Town of Milton – Rowland Street Highway Facility – Cold Storage PEMB

Addendum No. 1

June 12, 2023

SHEET: A001

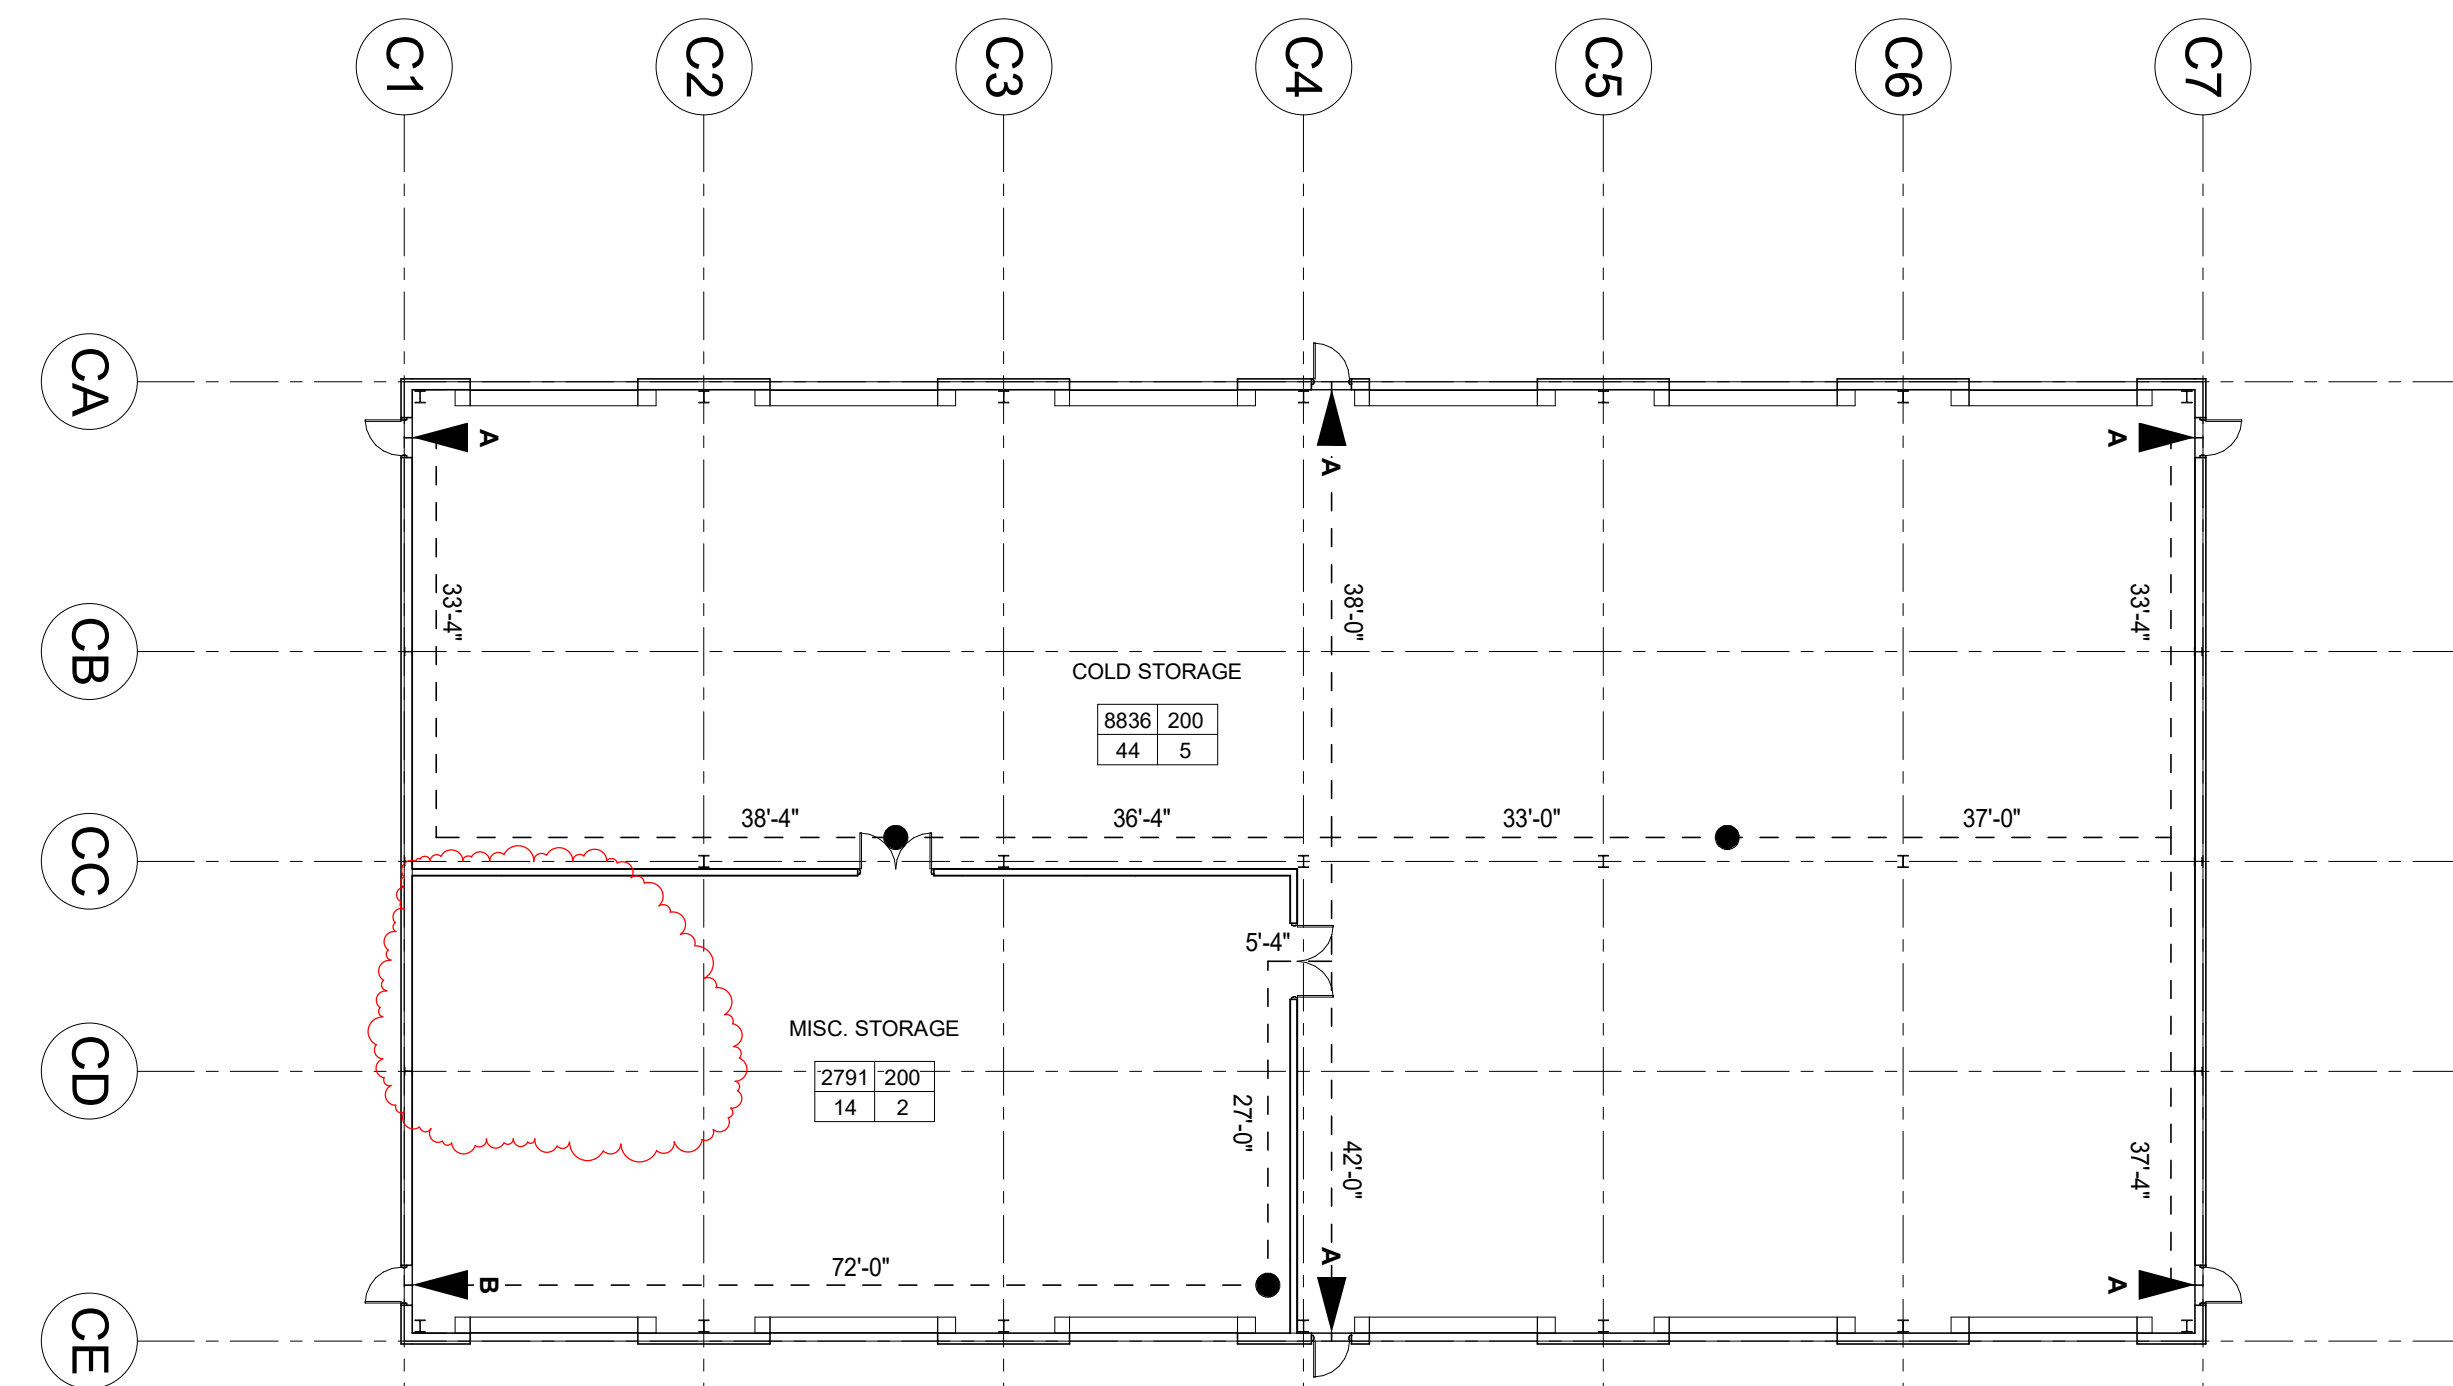
Item #3 – A001:

Updated preliminary design criteria & code requirements.

- RISK CATEGORY:** II
 - DEAD LOADS:** UNIFORM
 - ROOF:
 - 8" INSULATED METAL ROOF PANEL: 6 PSF
 - SOLAR PANEL ALLOWANCE (NON-BALLAST): 7 PSF
 - COLLATERAL LOAD: 10 PSF

- TOTAL ROOF DEAD LOAD: 23 PSF
 - LIVE LOADS:** UNIFORM CONCENTRATED
 - ROOF: 20 PSF 300 LBS
 - SNOW LOADS:** UNIFORM
 - GROUND SNOW LOAD, P_g: 50 PSF
 - FLAT ROOF SNOW LOAD, P_f: 42 PSF

SHEET:
A101

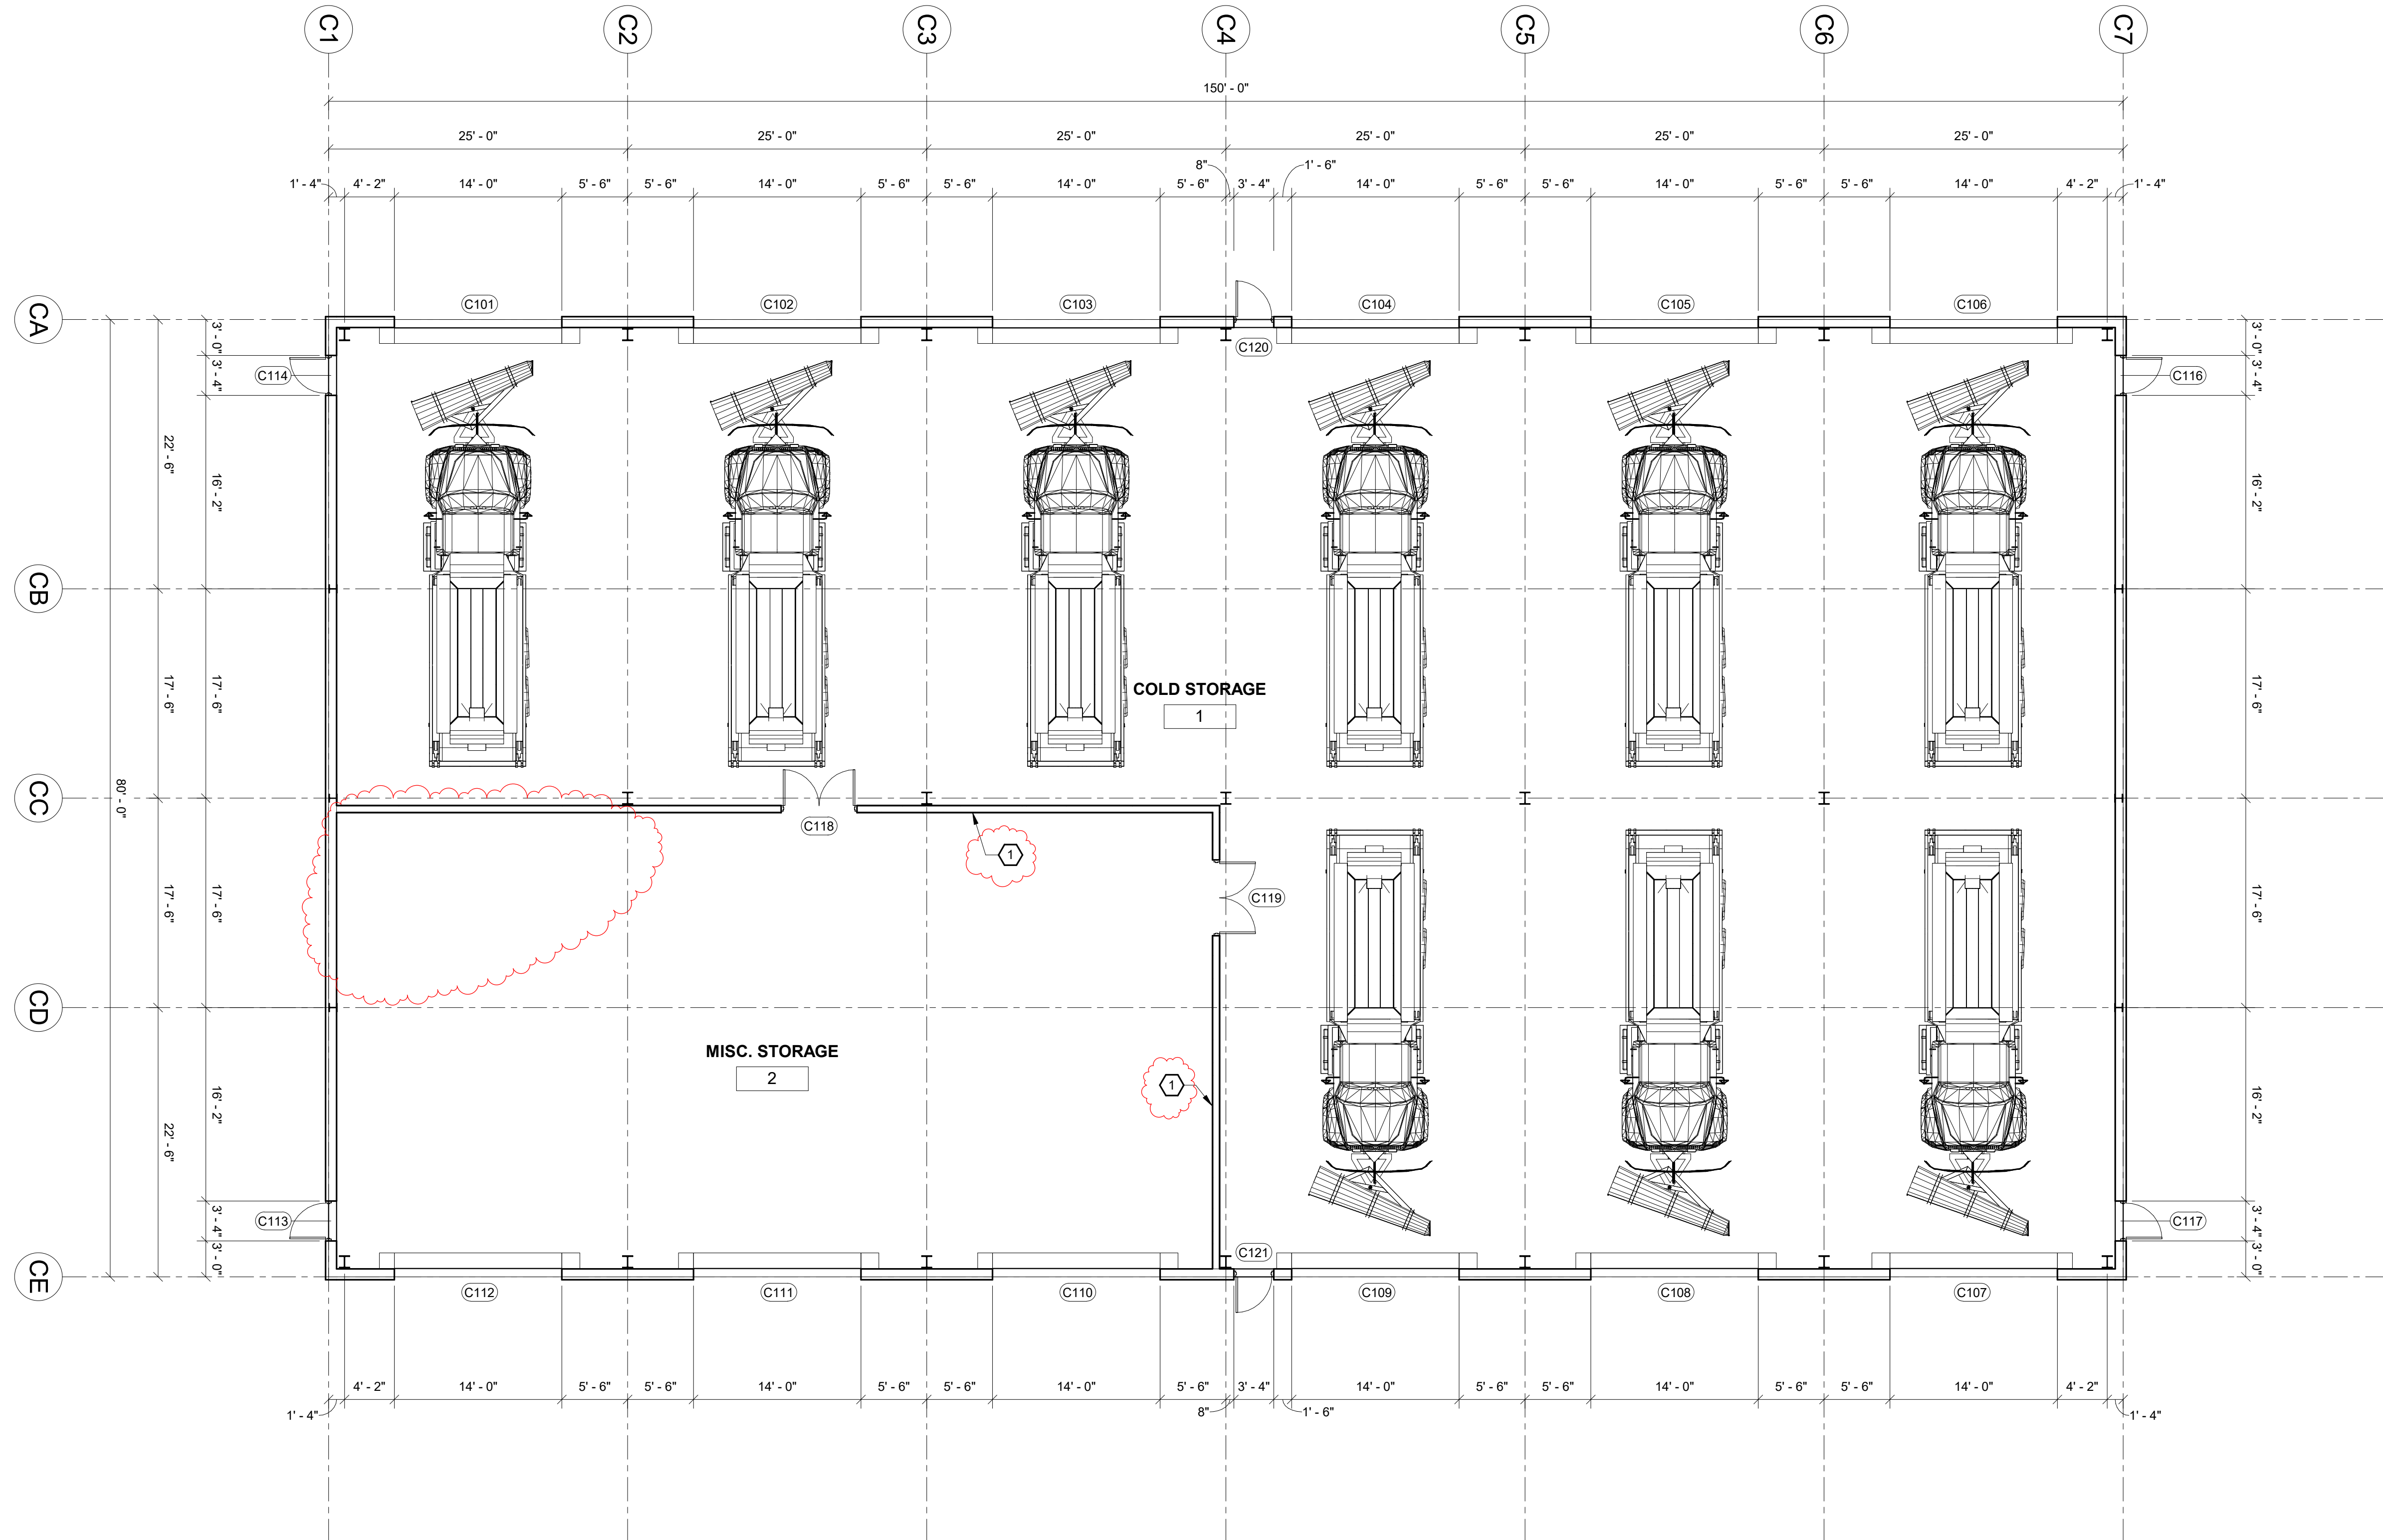
Item #4 – A101:

Delete lavatory & mech/electric room.

SHEET:
A800

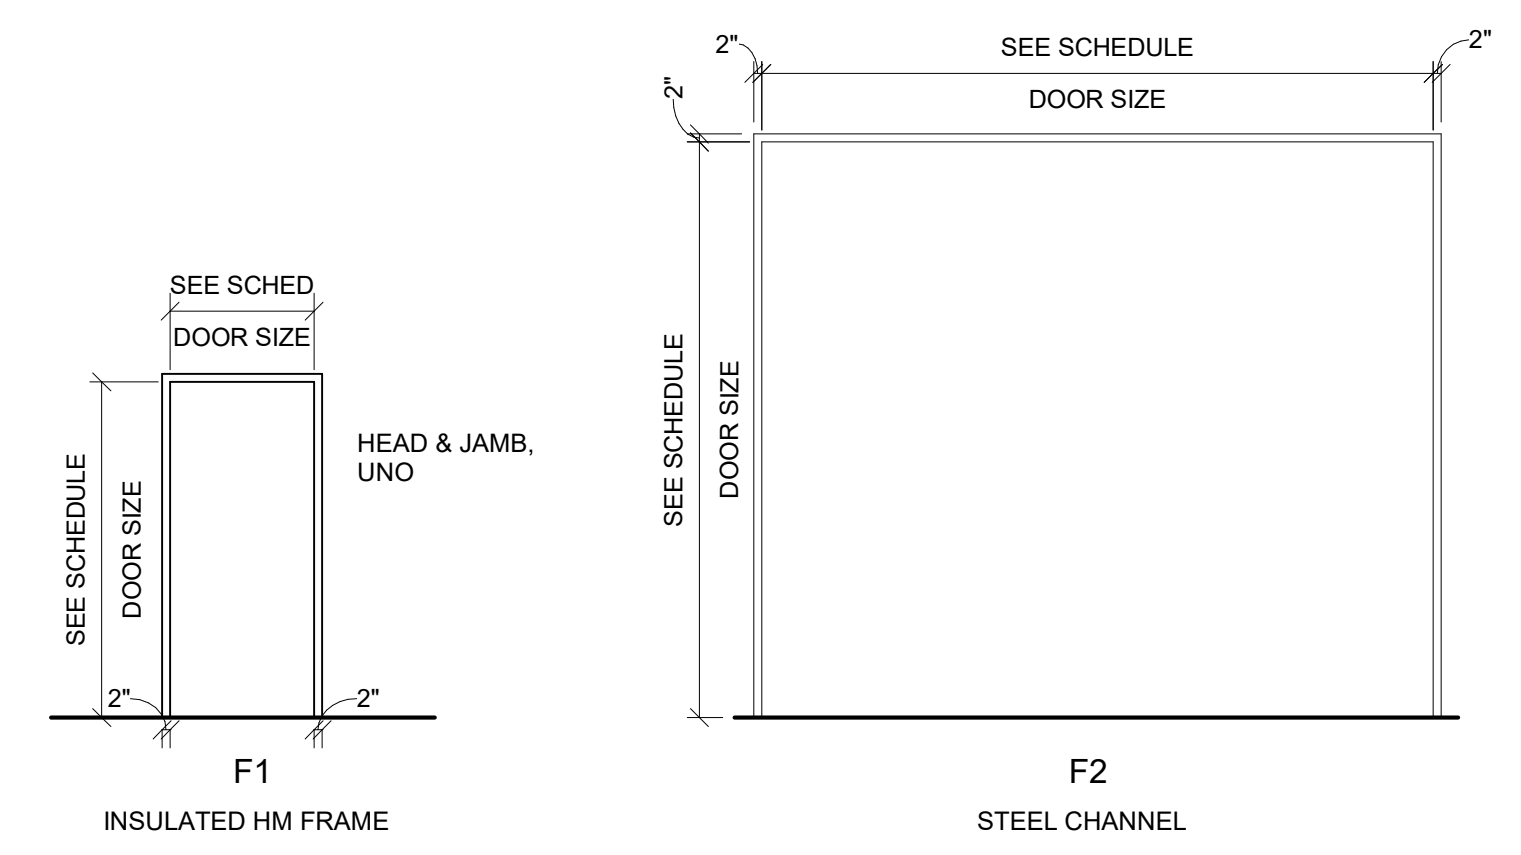
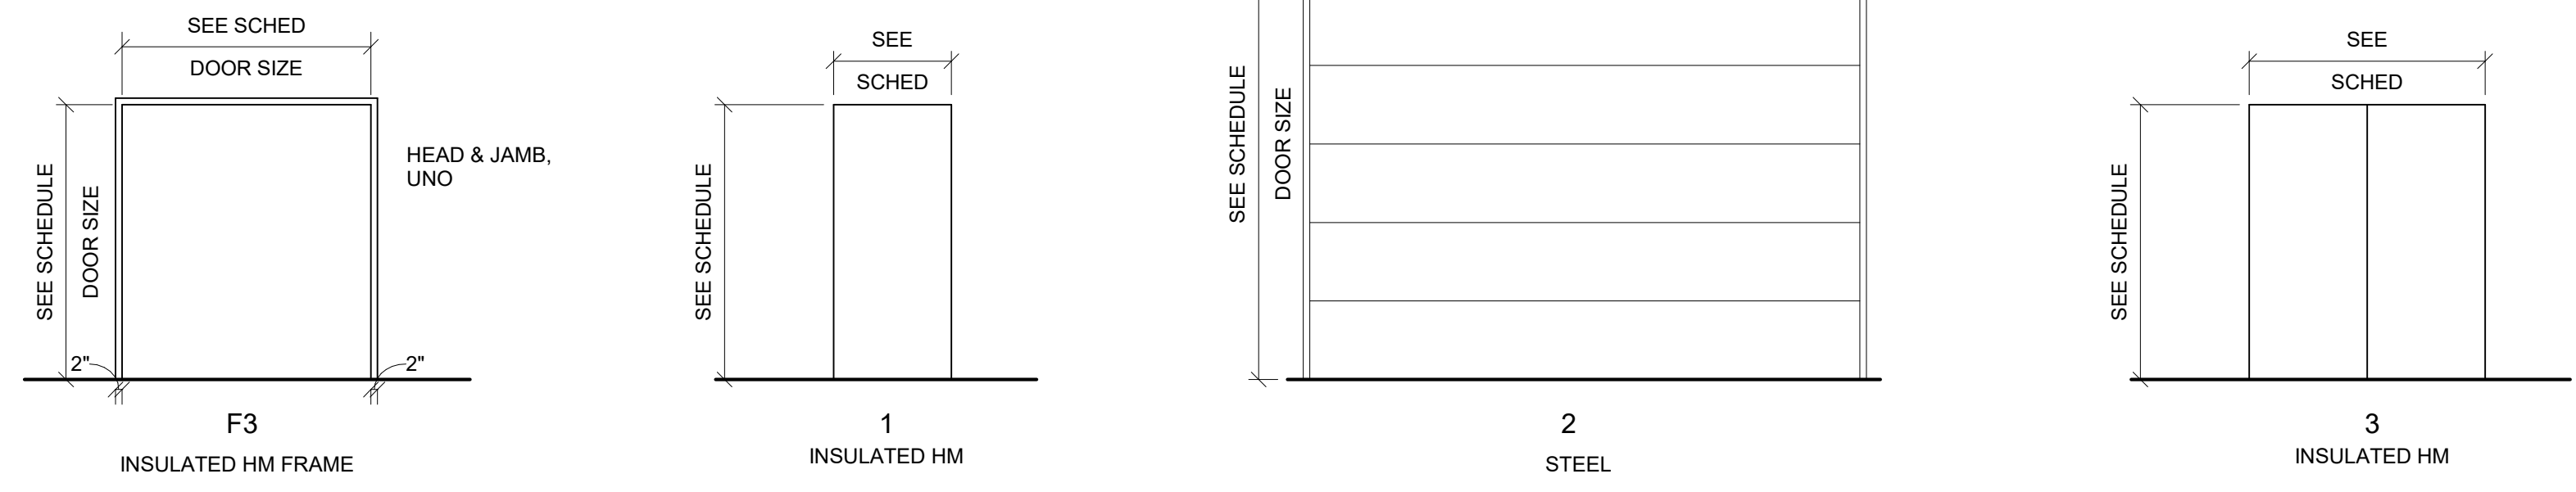
Item #5 – A800:

Delete lavatory & mech/electric room doors.
